July 17, 2003

Site Inspection, Holcim (US) Inc., Poverty Point, M/045/012, Tooele County, Utah

Inspection Date: July 14, 2003; Report Date: July 17, 2003

Poverty Point Holcim, US, Inc. M045/012

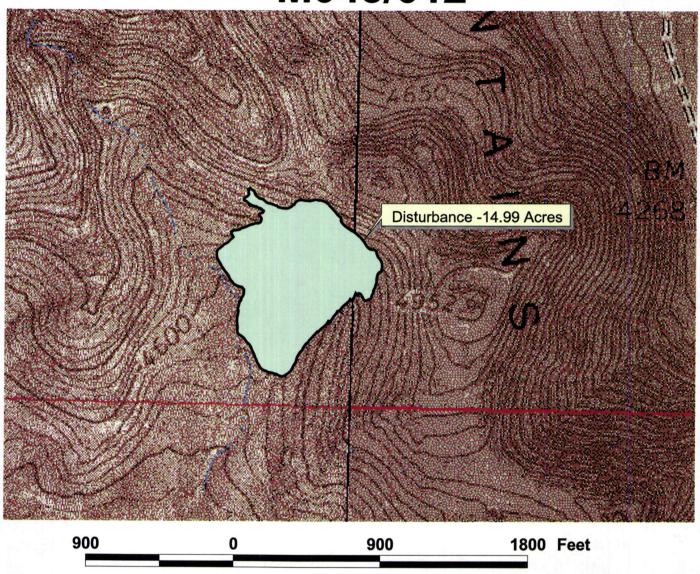
The survey (attached) included the quarry area and associated mine development roads used to access the upper development areas of the pit. The survey shows that the present disturbance at the site is a total of 14.99 acres. The quarry site is located on a SITLA lease.

While the present permitted acreage at the site is sufficient to cover the area that is presently disturbed, the areas that are disturbed are not the areas shown in the plan presently on file at the Division. This plan does not cover the additional 6.69 acres of disturbance at the quarry. It will be necessary for Holcim to amend the present plan to redefine the disturbances at the quarry. In addition, the bond will also need to be recalculated to cover these changes.
